**Subject:** MHI's Response to US-APWR DCD RAI No. 322-1999 (60-day response)

Response to Request for Additional Information No. 322-1999,  
Revision 0 (60-day response)

**US-APWR Design Certification**

**SRP SECTION:** 03.08.03 – Concrete and Steel Internal Structures of Steel  
or Concrete Containments

Figure 3.8.1-8 Containment Penetrations  
(Sheet 12 of 17)

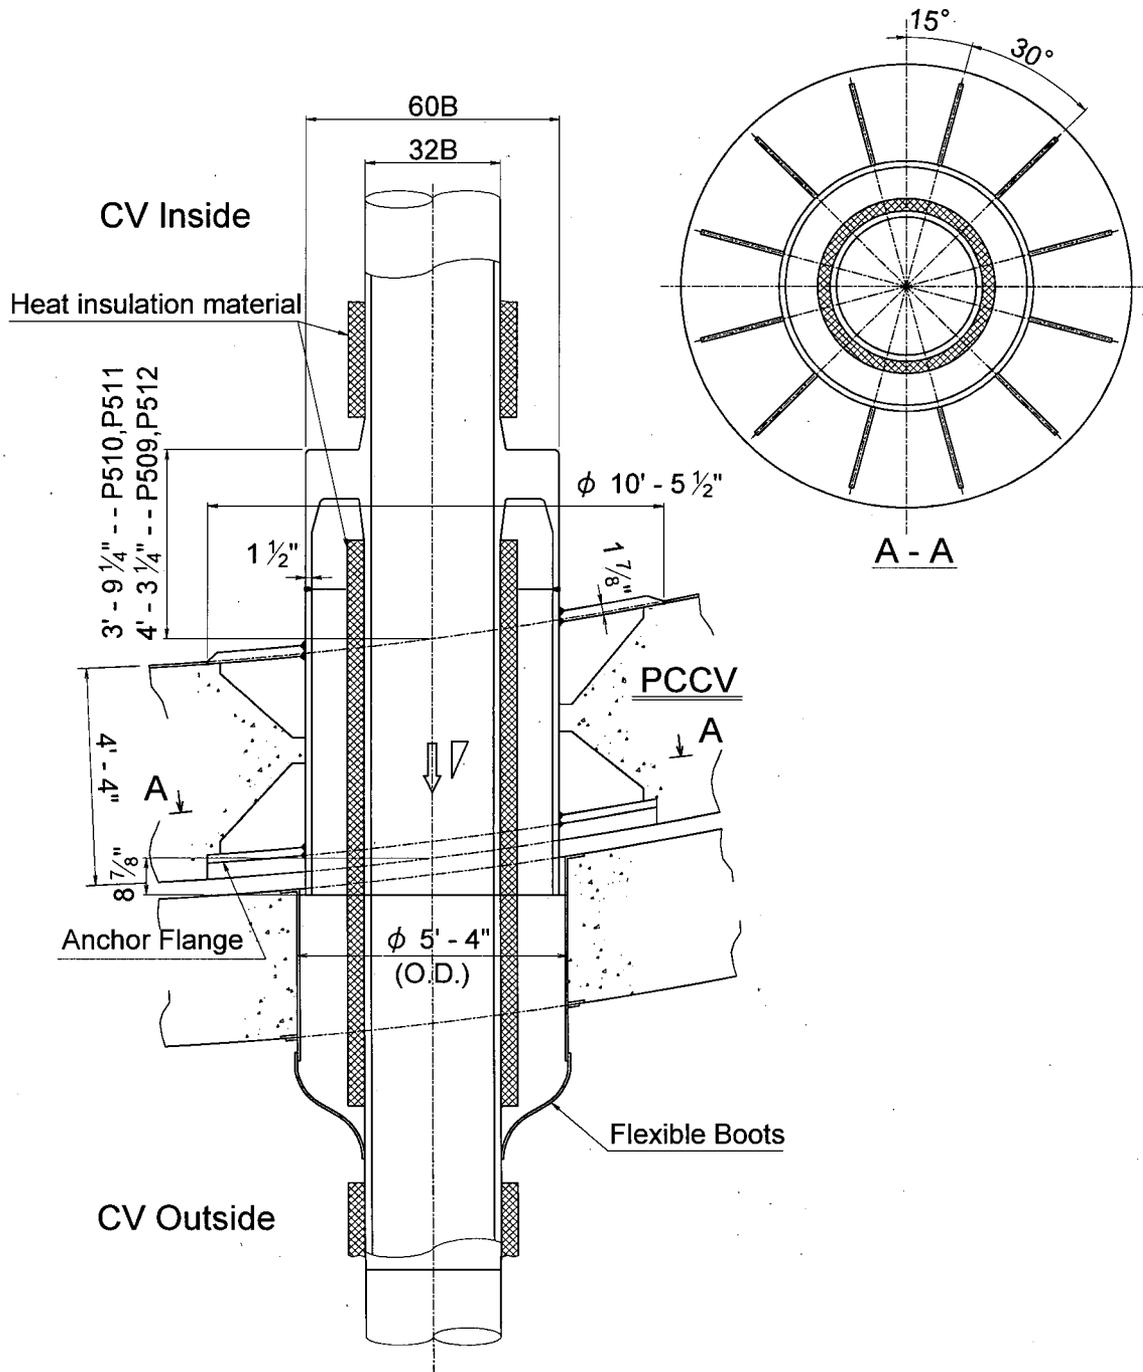
In reviewing the applicant's response to Question 06.02.06-11 dealing with containment vessel penetration cooling, concern was generated about the stress that would be placed on the in-containment penetration collar welds between the penetration sleeve and the end cap and between the end cap and the steam pipe. The penetration arrangement of concern is depicted in DCD Figure 3.8.1-8 (Sheet 12 of 16) on page 3.8-148 of the DCD. As shown, on the in-containment side of the penetration there is a full penetration weld between a thickened section of the steam pipe and the end cap (collar) and a corner weld between the penetration sleeve and the end cap (collar).

- Provide the stress analysis demonstrating the structural integrity of this weld over time for all loads and load combinations, including the effects of induced steam flow vibrational movements in the steam piping, and any other piping loads imposed on the penetration assembly. Also, provide the inspections and nondestructive tests to be performed on these welds to meet code requirements. In addition, confirm that the function of these welds is to provide the containment barrier leak tightness and structural support of the steam piping.

It is noted further that the weld details (i.e., between the penetration sleeves and the end caps and between the end cap and the piping) used in penetrations for the main steam lines, are also used for other major penetrations, including the Feedwater piping (DCD Figure 3.8.1-8, Sheet 13 of 16), and the SG Blowdown piping (DCD Figure 3.8.1-8, Sheet 14 of 16).

Welds located between the inner side of flat heads and pipes of PCCV penetrations for high-energy fluid system piping, main steam piping, feedwater piping, and SG blow down piping; do not satisfy the criterion of BTP 3-4, Part B, Item A(ii)(5).

These penetrations are modified with welded attachments to the flued head structure to satisfy the criterion of BTP 3-4, Part B, Item A(ii)(5) as shown in Figure 3.8.1-8 (Sheet 12 of 17) in MUAP-09003 (R0), US-APWR DCD RAI Tracking Report. See Figure 3.8.1-8 (Sheets 12, 13, and 14 of 17) below.

Figure 3.8.1-8 Containment Penetrations  
(Sheet 13 of 17)

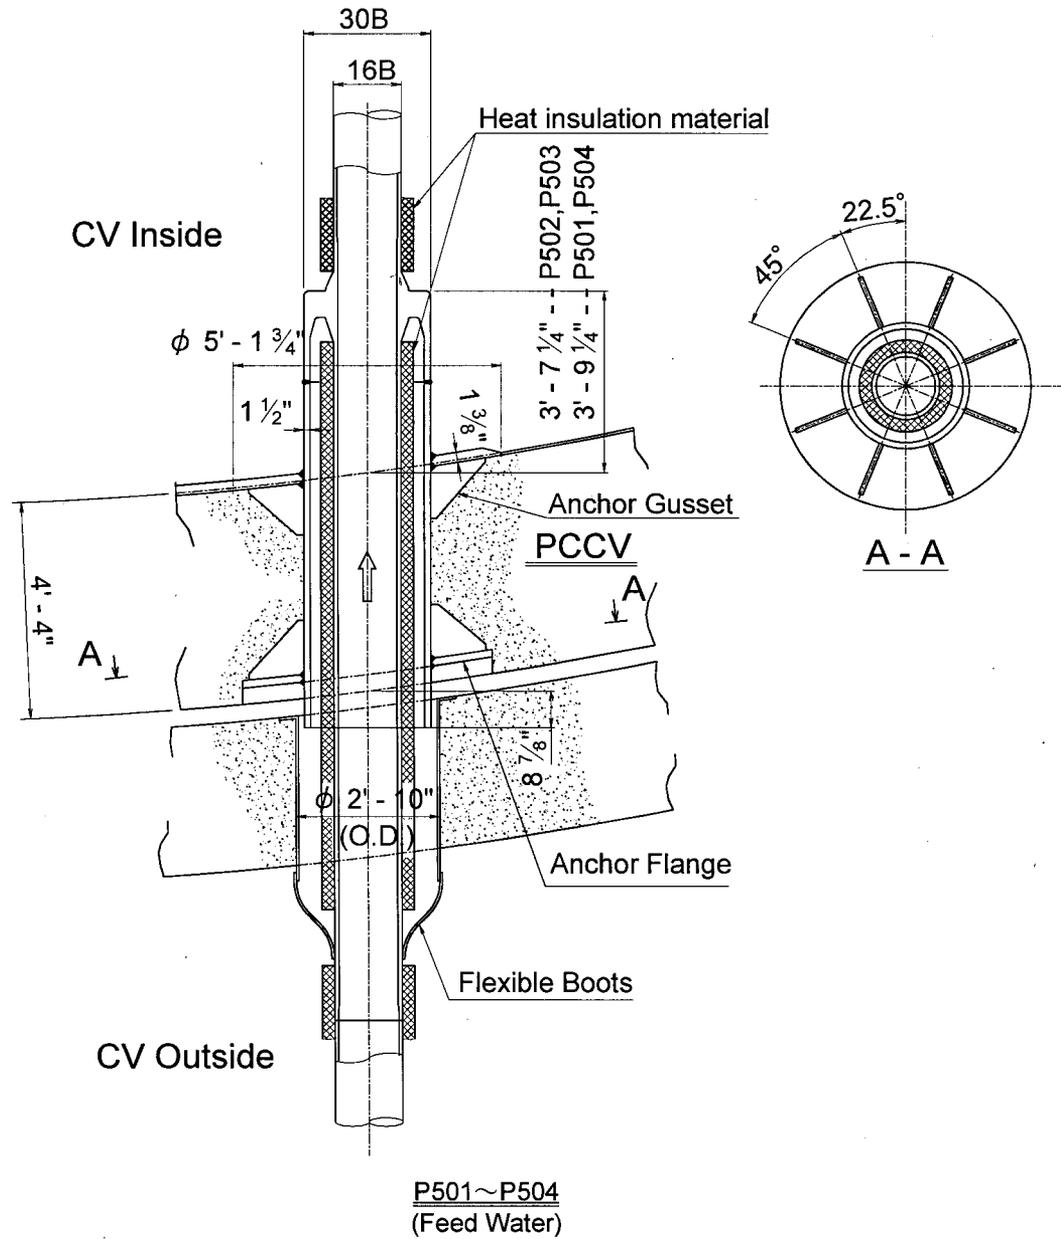
- Provide the stress analysis for these other major piping penetrations for all loads and load combinations, (including Feedwater piping and SG Blowdown piping), taking into account the piping loads imposed on the penetration assembly, thermal effects, and any dynamic loads anticipated from the piping systems in these penetrations.
-
